Access Compliance Report

Public Rights-of-Way

(Curb Ramps)

Intersection ID: 10039485	Main Street: TELEVISION_PL	Cross Street: N/A	Location: NW
ADA ID: 593438C564CE	Ramp Type: PerpDiag	Initial Pass/Fail: Fail	Overall Compliance: No
Severity Score: 22.5			
Codes/Mitigation Info/Possible Solution		Field Measurements/Component Compliance

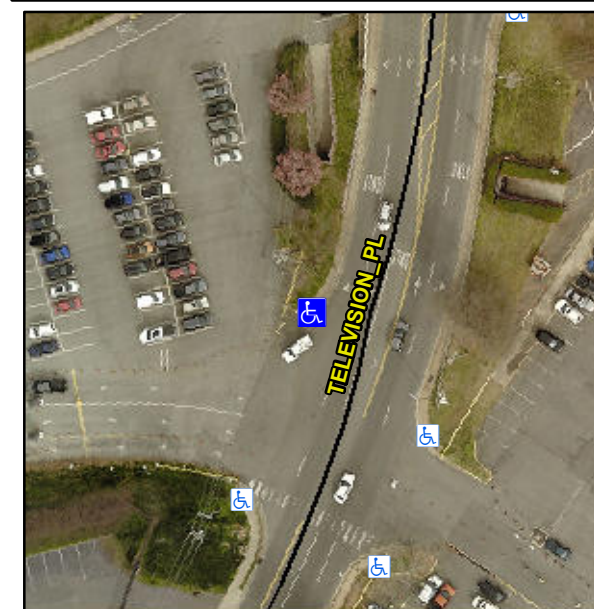
Not Found, R304.5.1, R304.2.2, R304.5.3

Compliance	Description	Data	Compliance	Description	Data
N/A	Ramp Length (in)	48.0	No	Ramp Slope (%)	10.9
No	Ramp Width (in)	38.0	No	Ramp XSlope (%)	2.2
N/A	Flare Type LT	N/A	N/A	Flare Type RT	N/A
N/A	Flare Slope LT (%)	N/A	N/A	Flare Slope RT (%)	N/A
N/A	Flare Traversable LT?	N/A	N/A	Flare Traversable RT?	N/A
N/A	Landing Length (in)	N/A	N/A	DWS Provided?	N/A
N/A	Landing Width (in)	N/A	N/A	DWS Contrast?	N/A
N/A	Landing Slope (%)	N/A	N/A	DWS Length (in)	N/A
N/A	Landing X Slope (%)	N/A	N/A	DWS Full Width?	N/A
N/A	Landing Curb? (Y/N)	N/A	N/A	DWS Offset (in)	N/A
N/A	Shared Landing?	N/A			
N/A	Gutter Ponding?	N/A	N/A	Gutter Slope (%)	N/A
N/A	Gutter Lip Ht (in)	N/A	N/A	Gutter X Slope (%)	N/A
N/A	Painted X Walk1?	No	N/A	Painted X Walk2?	No
	X Walk 1 Direction	To SW		X Walk 2 Direction	To SE
N/A	X Walk 1 Width (in)	N/A	N/A	X Walk 2 Width (in)	N/A
	X Walk 1 Slope (%)	7.4		X Walk 2 Slope (%)	6.9
	X Walk 1 X Slope (%)	3.8		X Walk 2 X Slope (%)	5.2

Remove & Replace Curb Ramp With Two New Directional Ramps or Equivalent.
